SEQUOYAH NUCLEAR PLANT (SQN) UNITS 1 AND 2

(TVA-SQN-TS-95-11, REVISION 1)

DESCRIPTION AND JUSTIFICATION FOR

REVISION OF OVERTEMPERATURE AND OVERPOWER

Parametric Study Curves
For Margin To Trip

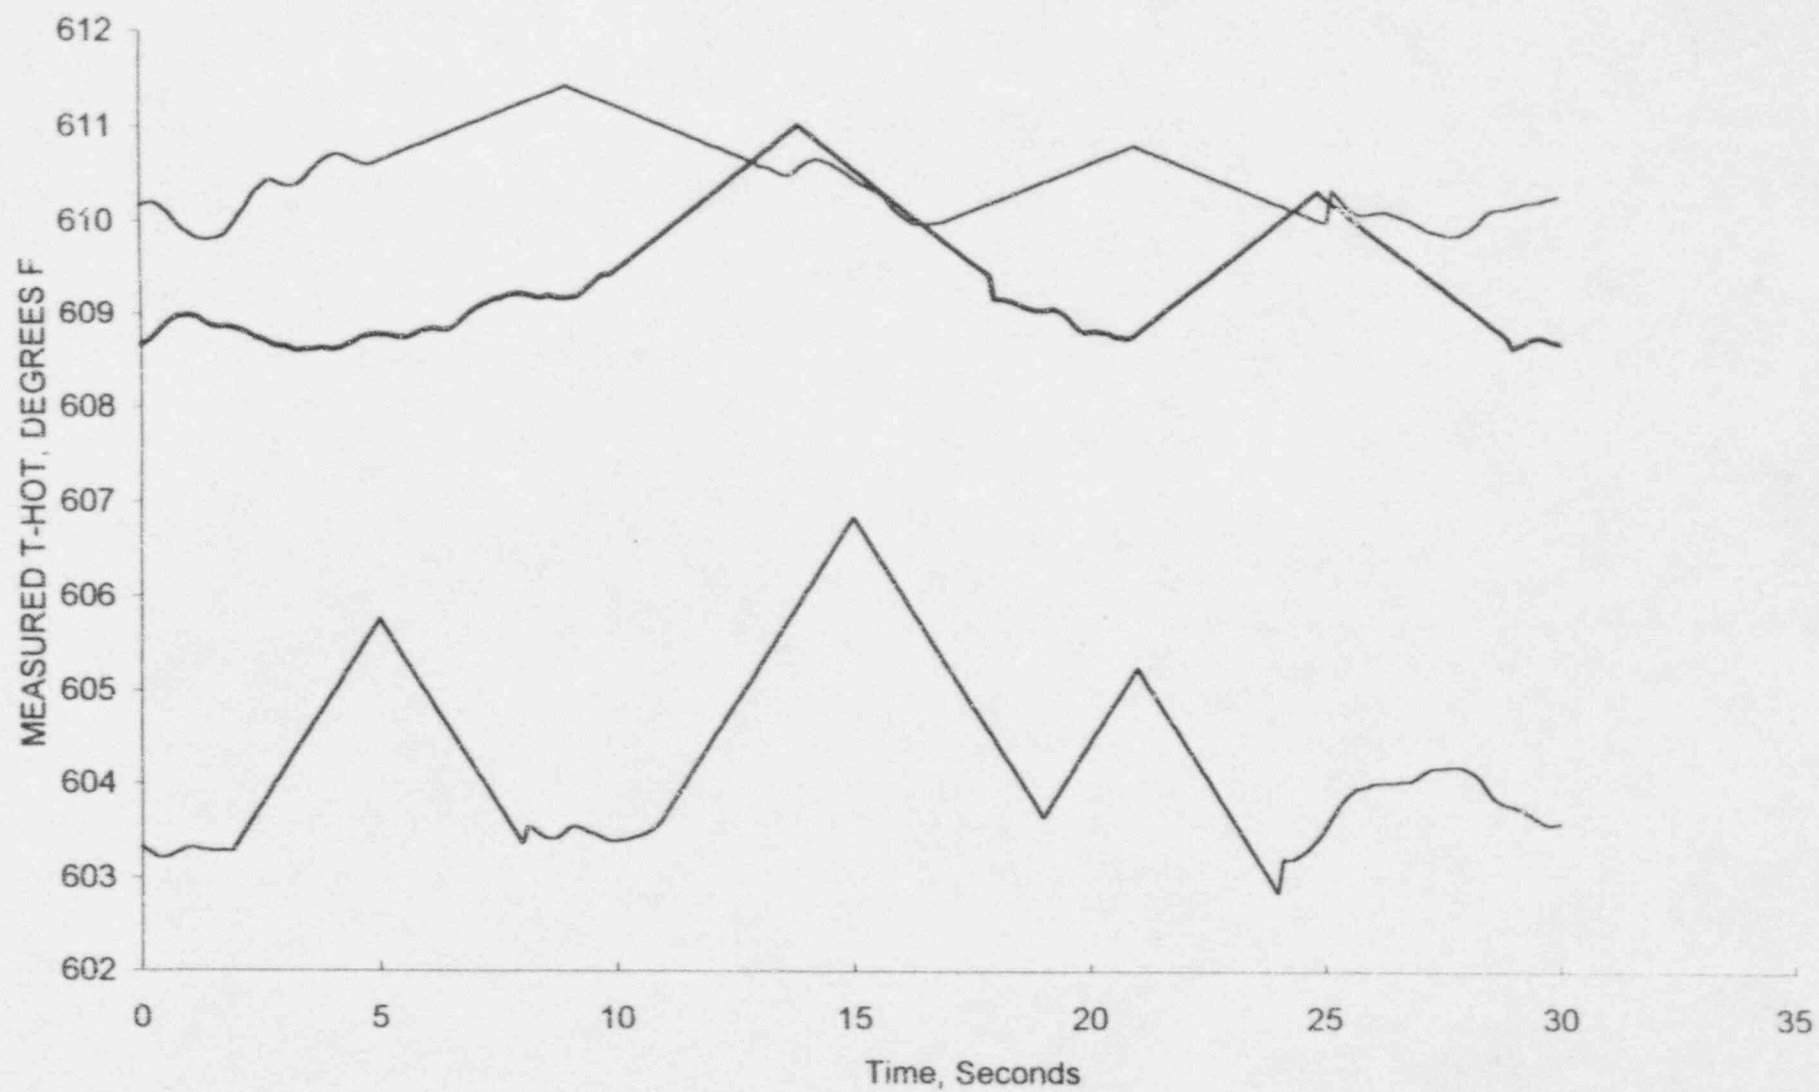
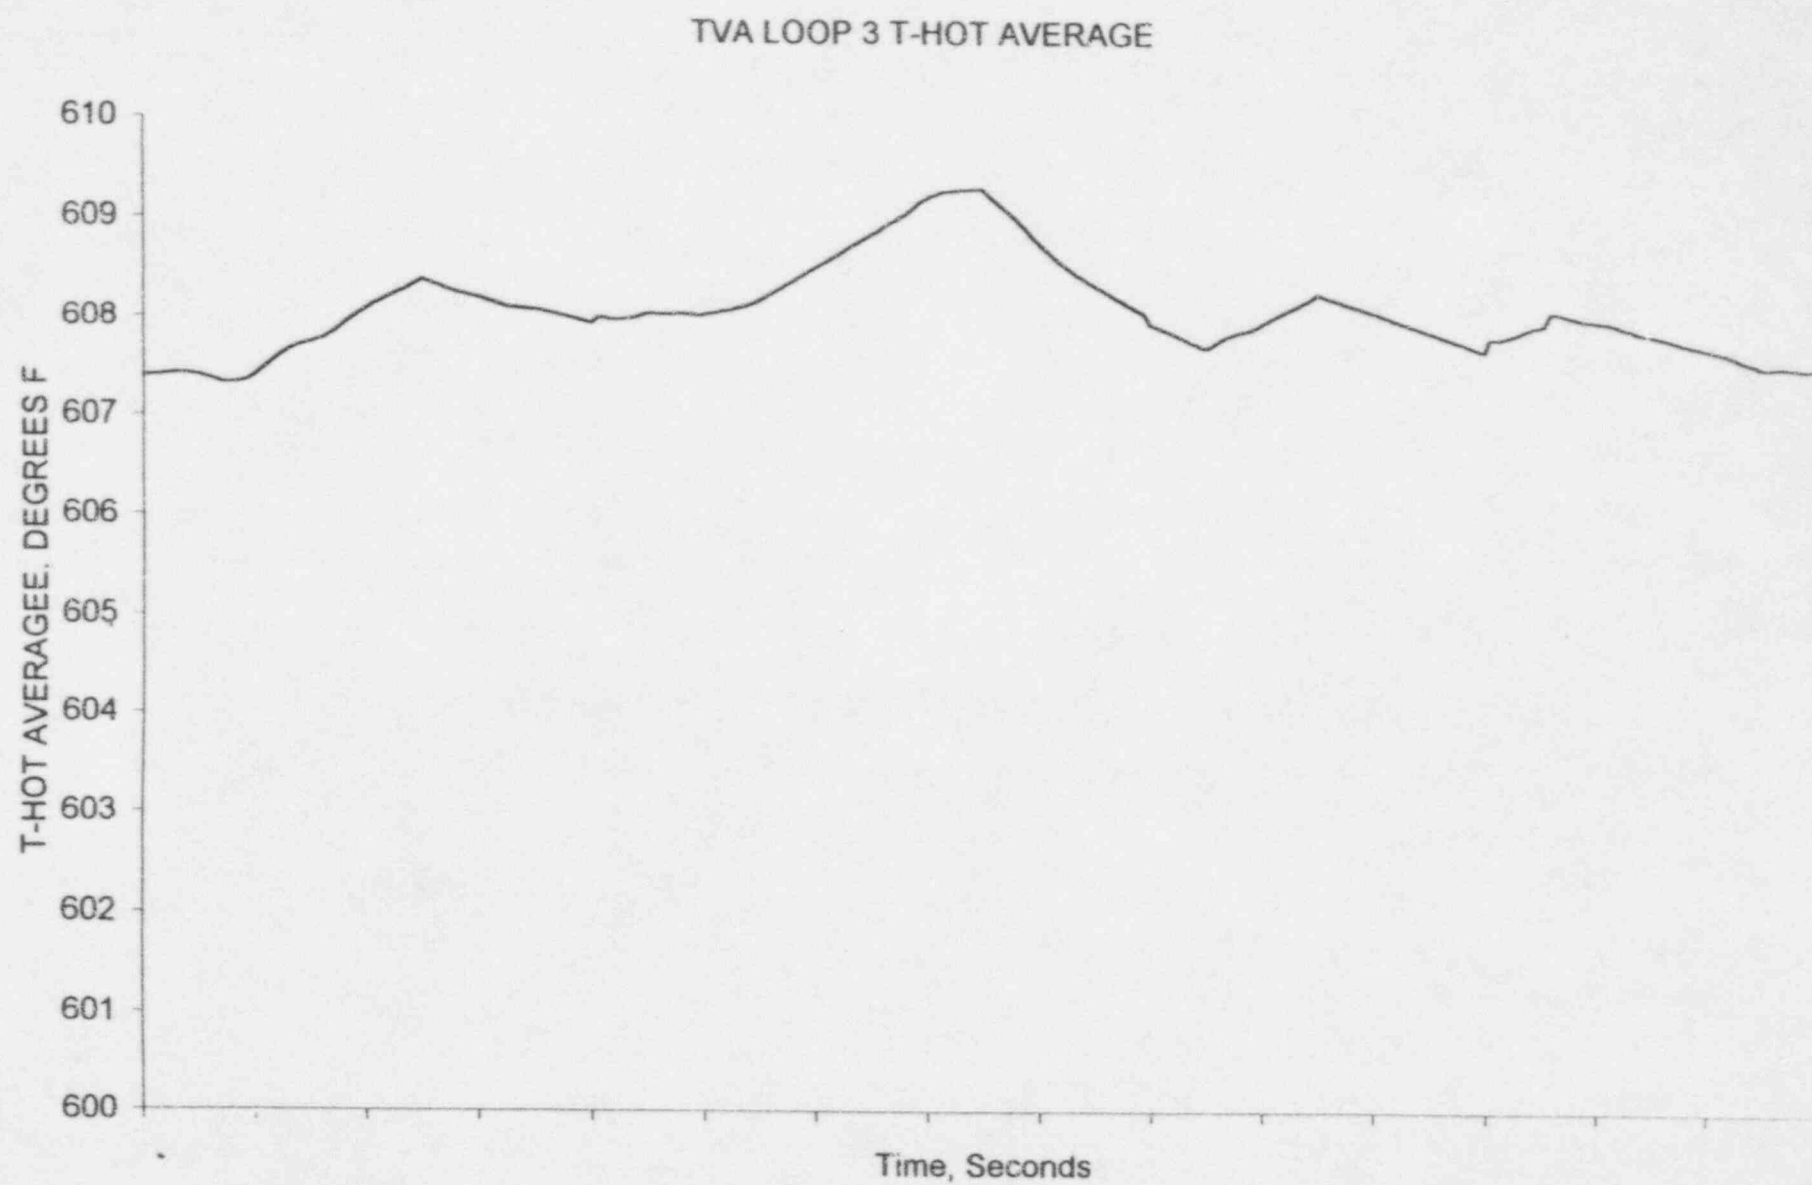
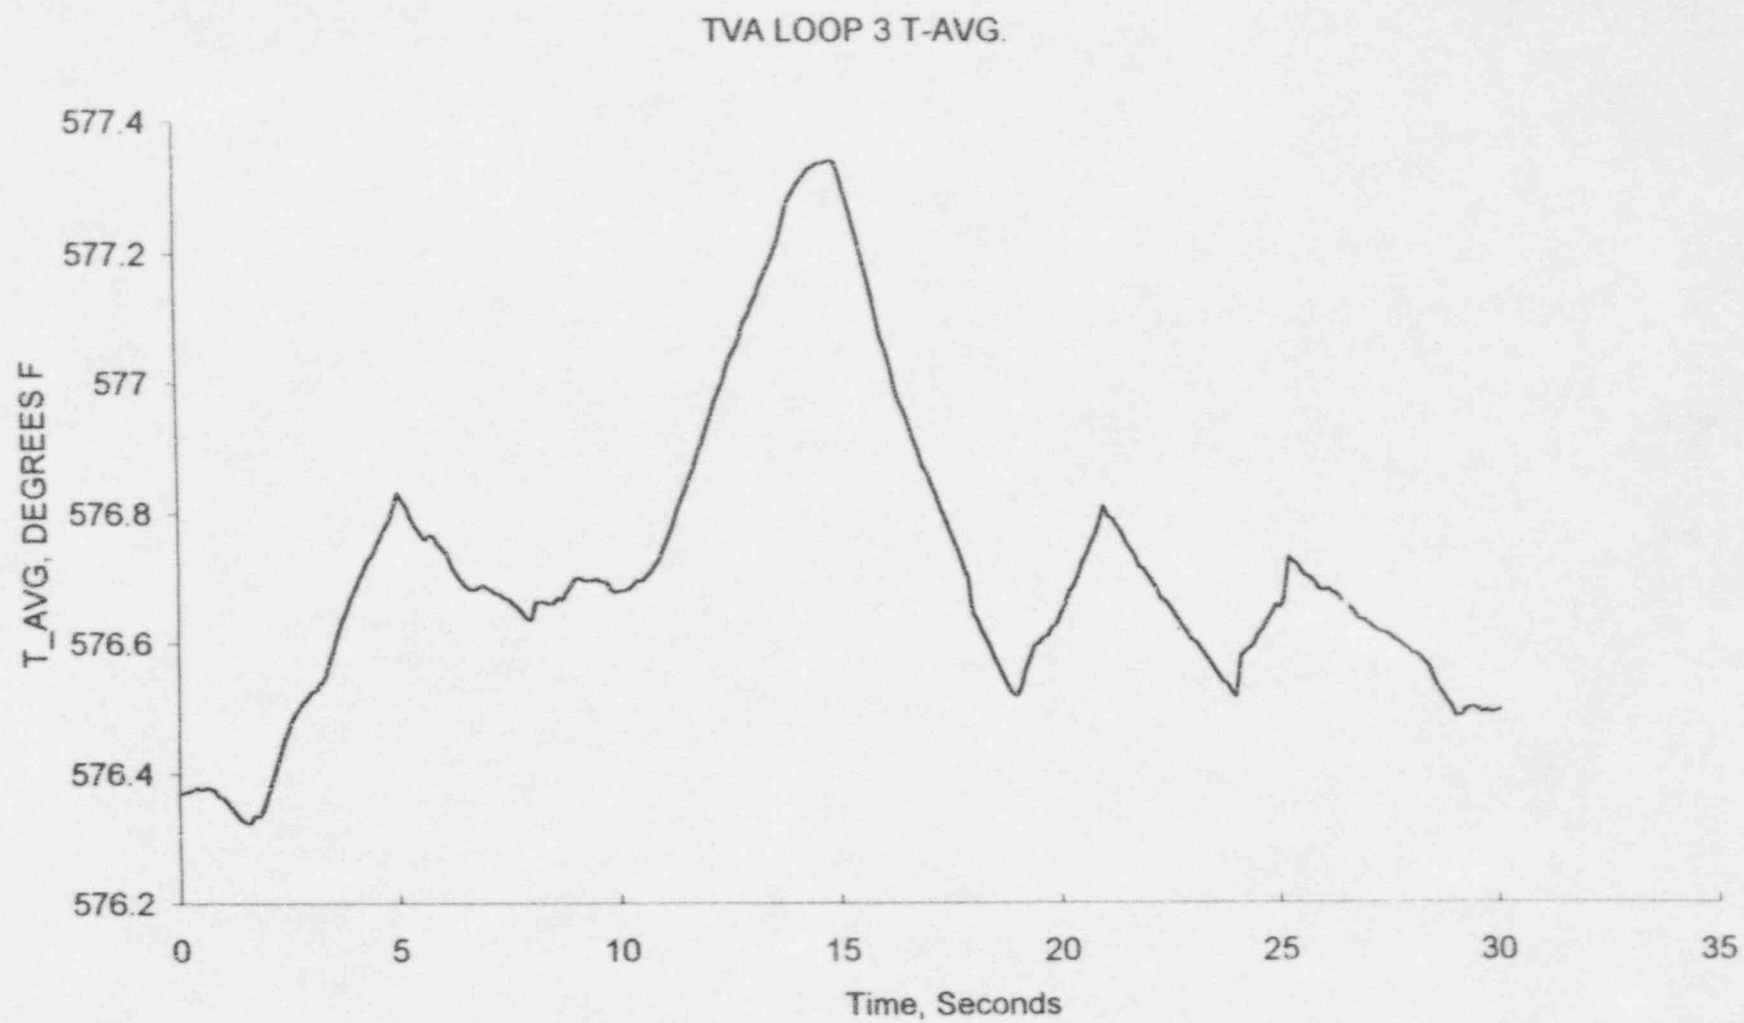
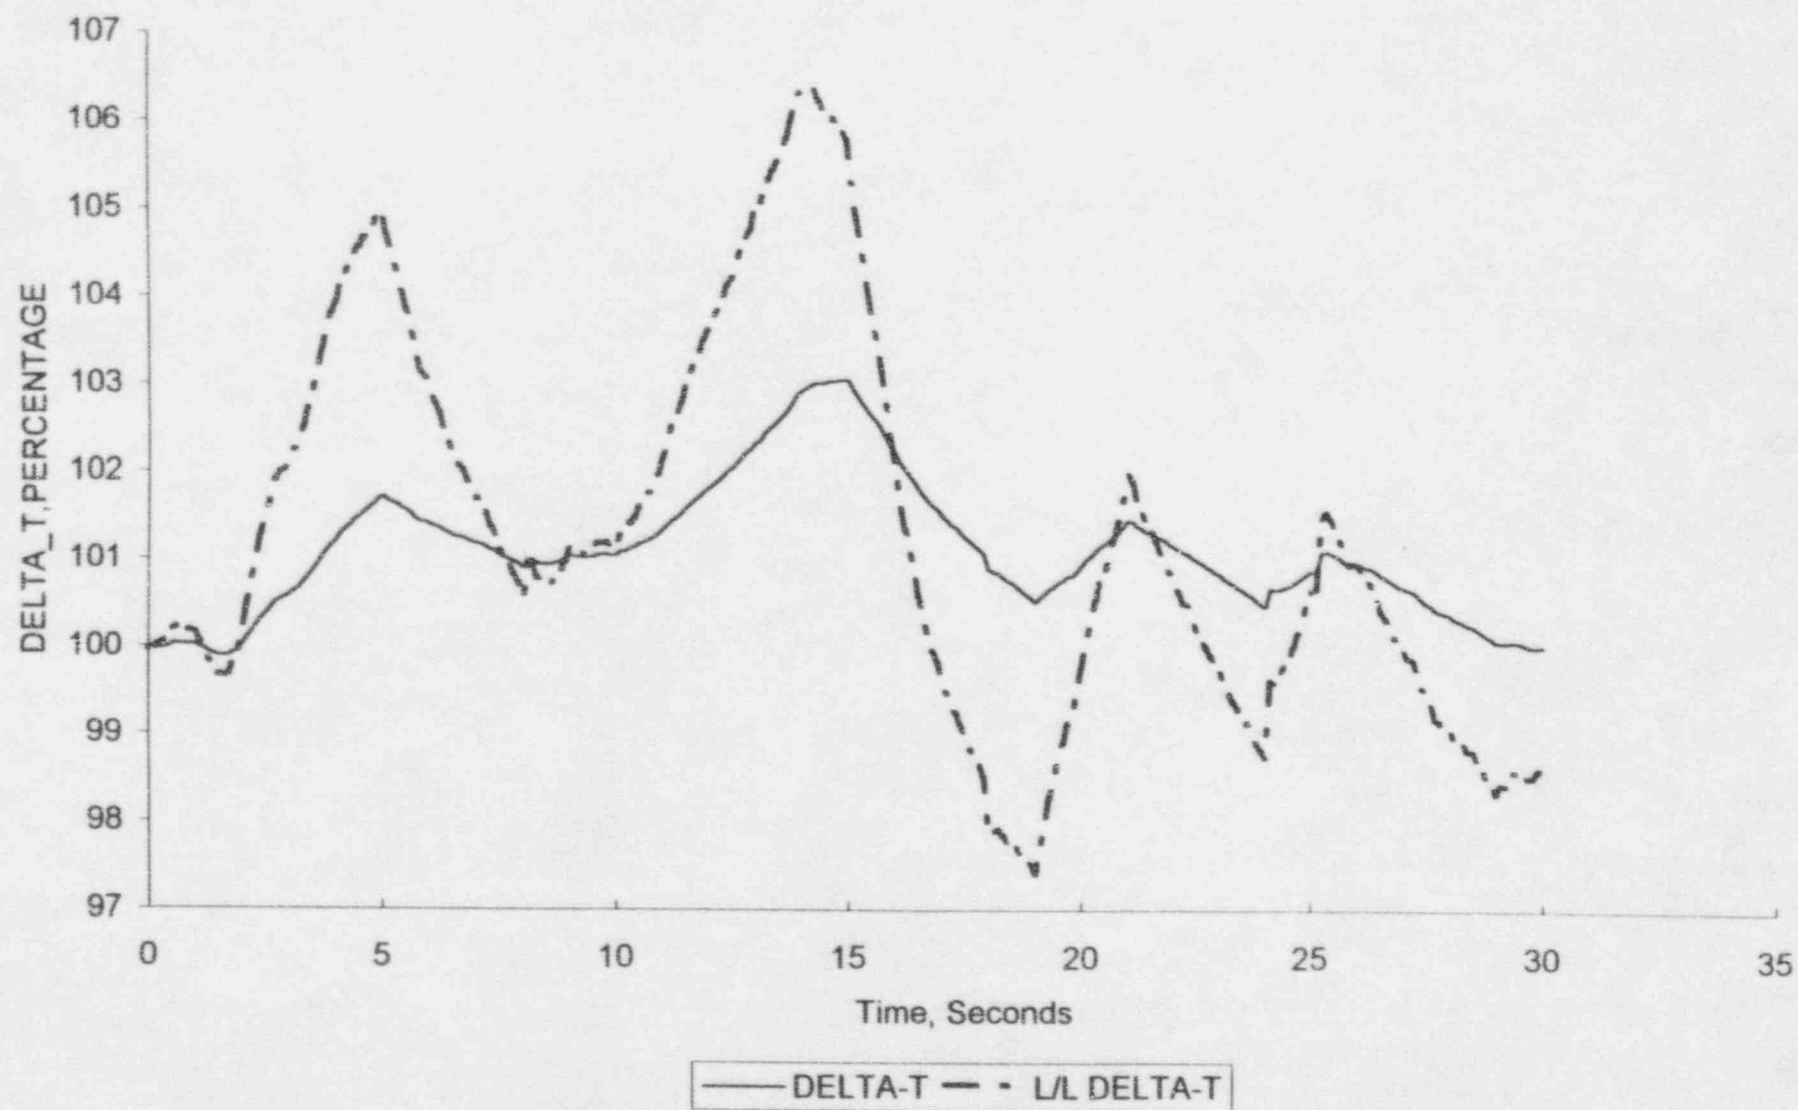
The hypothetical RTD signals are shown in Figure 1. It should be noted that there are several combinations of the temperature ramp rate and maximum amplitude that would result in a one percent OPΔT margin. The T-hot RTD signals shown in Figure 1 have a rise time of four seconds, a typical RTD time constant. If the rate of increase is higher than that simulated, a smaller temperature increase would result in OPΔT alarms/trips. Also, if the actual rate of temperature increases are lower than that simulated, the margin recovered will be more than that determined with a four second rise time.

The hypothetical T-hot signature is shown in Figure 1. The T-hot average (Figure 2) and T-avg (Figure 3) are then determined using a corresponding T-cold. The delta-T calculated from the above T-hot/T-cold variations are shown in Figure 4 along with the lead/lag compensated delta-T for a lead/lag ratio of 12/3. This lead/lag delta-T is compared with the OPΔT/OTΔT setpoints (Figures 5 and 6) to calculate the margin to OPΔT/OTΔT (Figures 7 and 8). As shown in Figure 7, the current OPΔT margin is about 1%. The same temperature fluctuations are used to calculate OPΔT margin for a lead/lag ratio of 8/3 and 5/3 (Figure 9).

The results are shown in Table 1. If the lead/lag ratio is reduced from 12/3 to 5/3, the OPΔT margin increased from 1.0% to 3.6%.
